SUBJECT: **DEMONSTRATION / DELIVERY HOLD - Safety Recall 15S19 - Supplement #1**
Certain 2015 Model Year Mustang Vehicles Equipped with 2.3L Engines
Fuel Tank, Vapor Line, and Parking Brake Cable Heat Shielding

REF: **DEMONSTRATION / DELIVERY HOLD - Safety Recall 15S19**
Dated June 24, 2015

New! REASON FOR THIS SUPPLEMENT

FIGURE 1

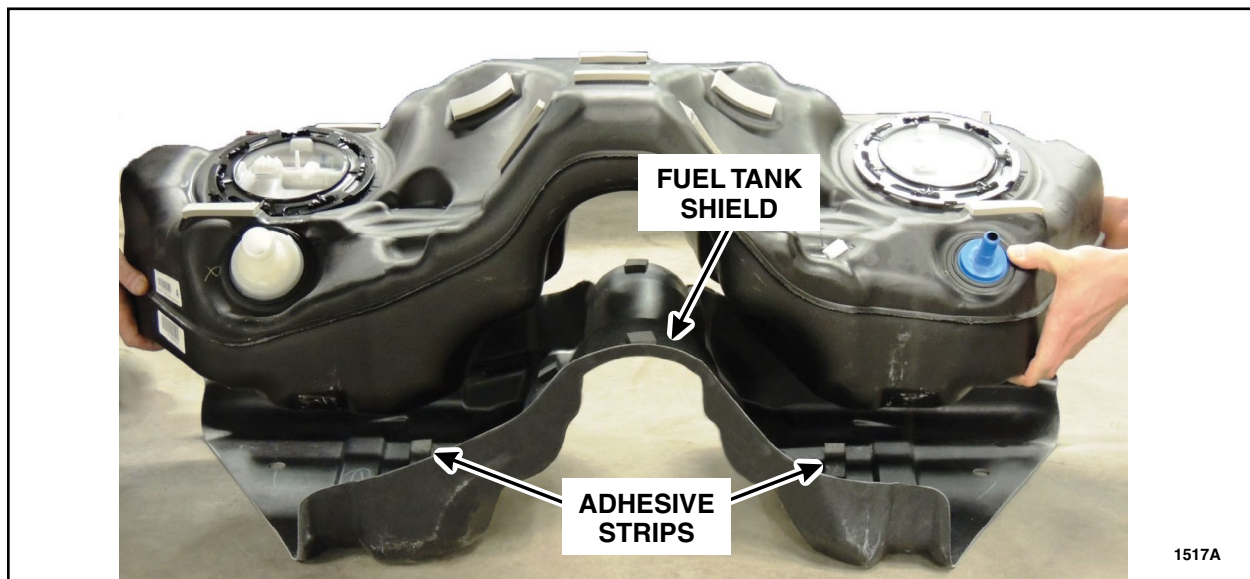
1. Remove the fuel tank. Please follow the Workshop Manual (WSM) procedures in Section 310-01.
2. Remove the fuel tank shield by pulling to release the adhesive strips that secure the shield to the tank. See Figure 1.

FIGURE 2

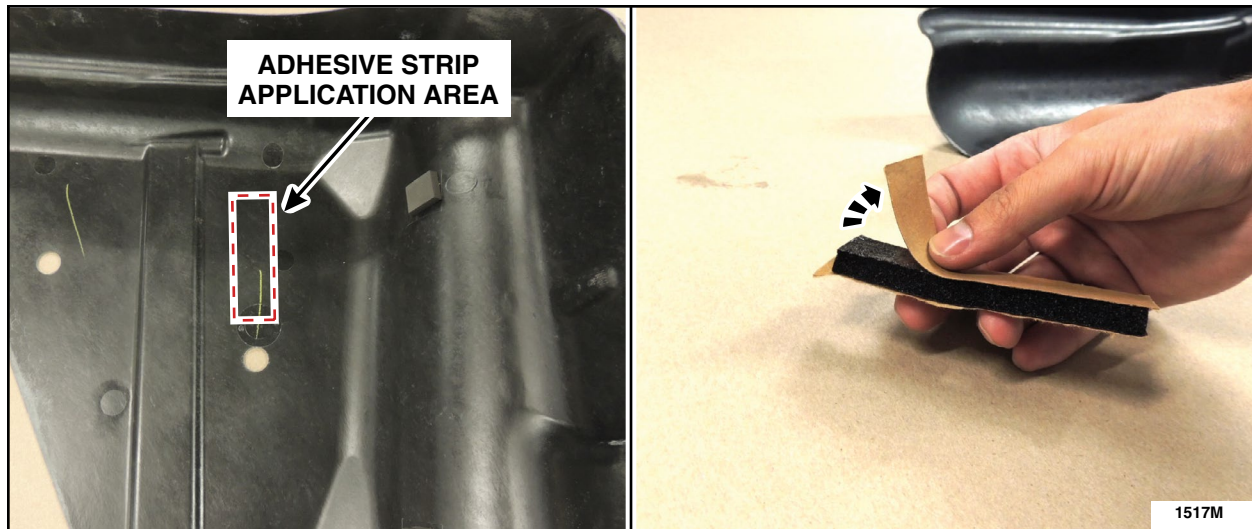
4. Locate the adhesive strip application areas on both sides of the new fuel tank shield. Peel off one side of the protective film from each adhesive strip and apply the strips to the new fuel tank shield. See Figure 2.

NOTE: LH side shown, RH similar.

FIGURE 5

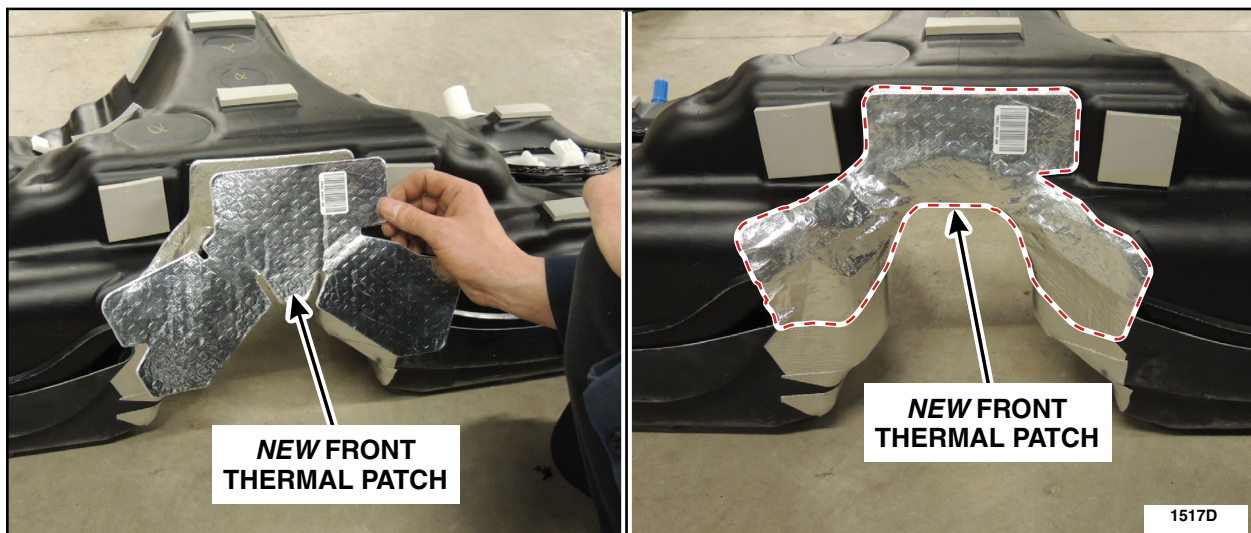
6. Apply *new* thermal patch over the existing thermal patch at the front of the fuel tank. See Figure 5.

FIGURE 6

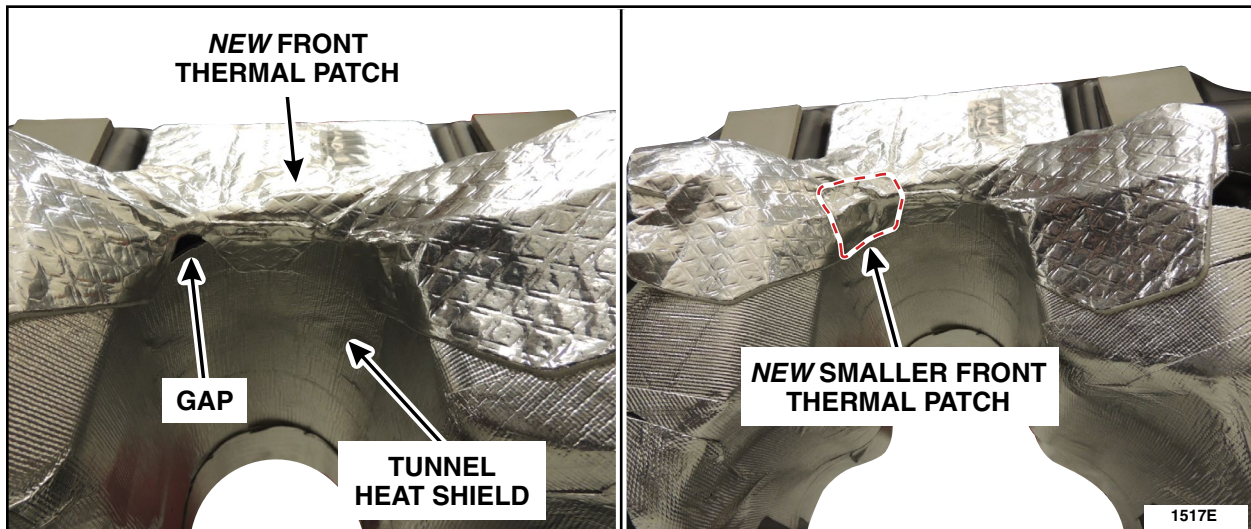
7. Apply the *new* smaller thermal patch over the gap between the tunnel heat shield and *new* front thermal patch. See Figure 6.

FIGURE 7

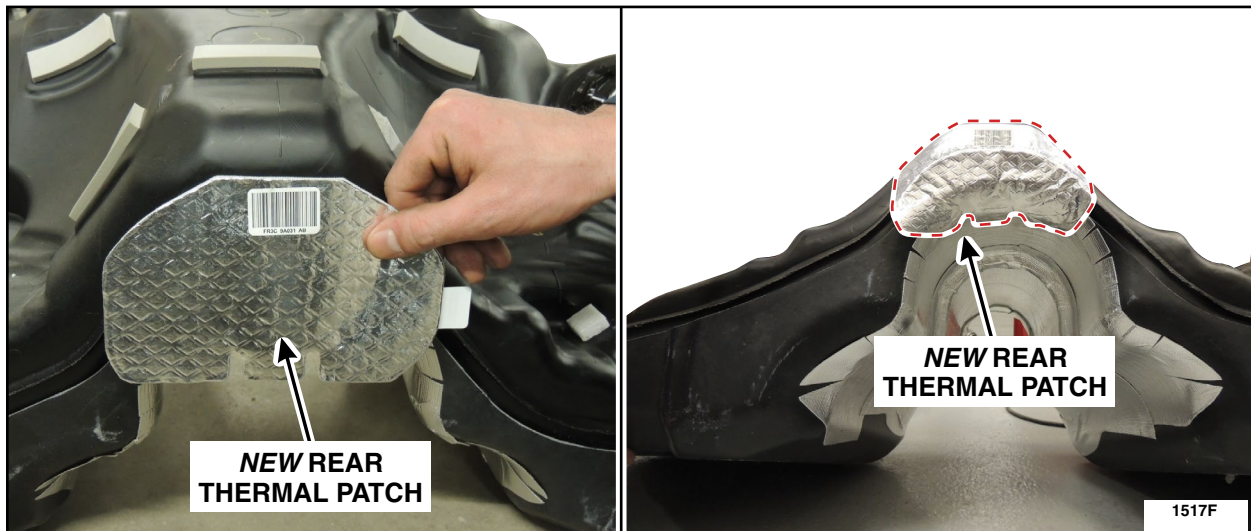
8. Apply *new* thermal patch to the rear of the tank. See Figure 7.

FIGURE 8

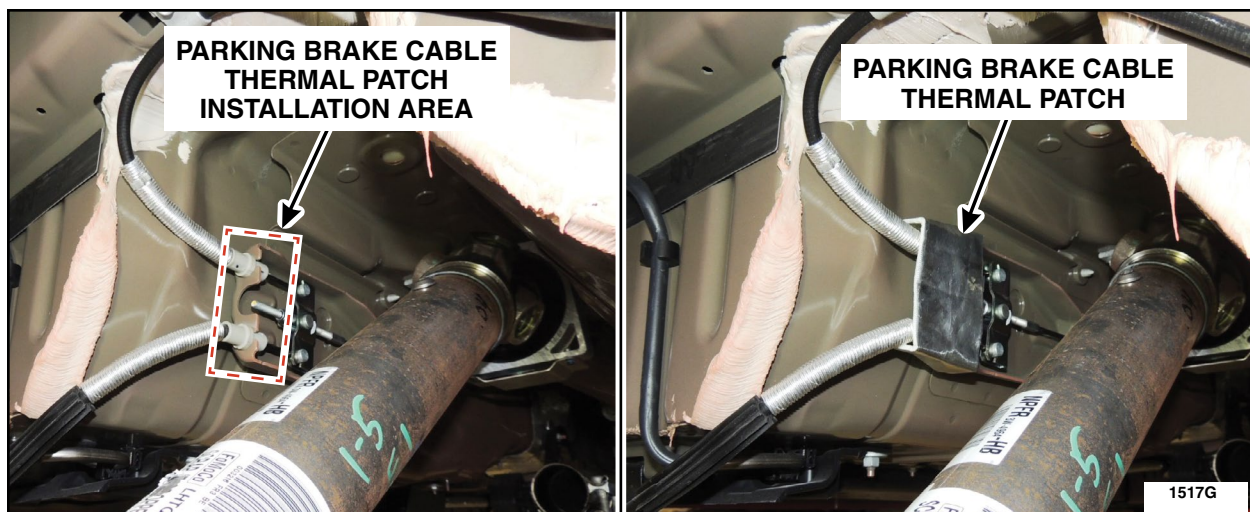
NOTE: Ensure there is no contact between the patch and the moving parts of the cable.

10. Apply *new* thermal patch over the parking brake cable retention collars. See Figure 8.

FIGURE 9

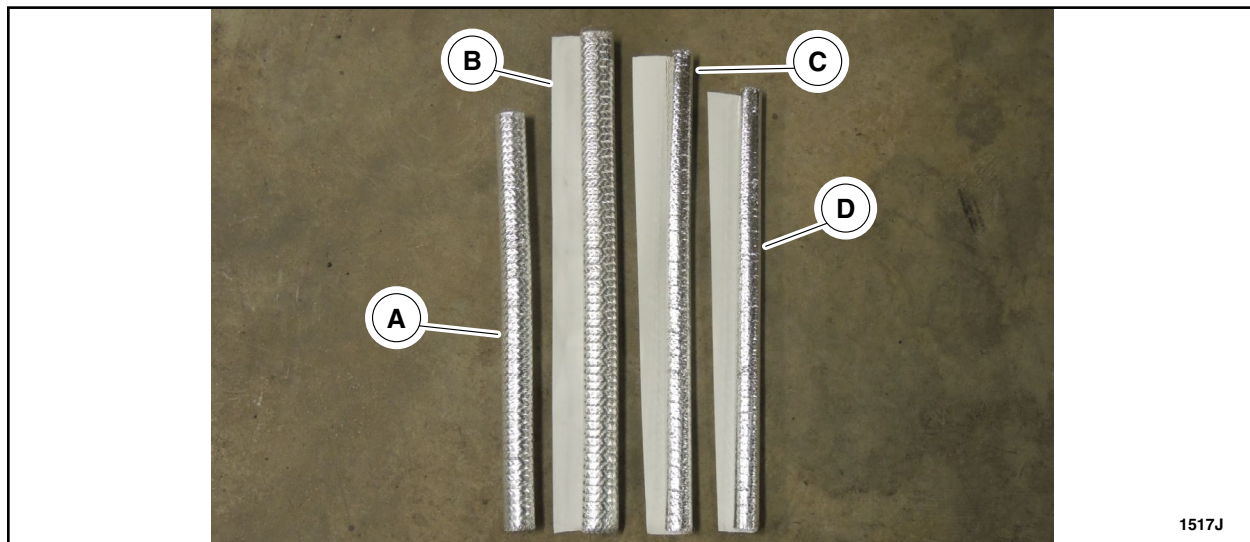
11. Install the thermal wraps onto the vapor lines above the rear sway bar. For steps 10b-10d, gradually slide the thermal wraps over the vapor lines, peeling back the protective film and folding the adhesive flap over to seal the wrap over the vapor line. See Figures 9 through 12.

- a. Remove the fresh-air hose from the rear subframe and slide the thermal wrap (19mm dia. x 300mm) over the hose. Reinstall the fresh-air hose to the frame rail.
- b. Install thermal wrap (19mm dia. x 365mm) to canister load line.
- c. Install thermal wrap (13mm dia. x 350mm) to canister recirculation line.
- d. Install thermal wrap (13mm dia. x 320mm) to purge line.
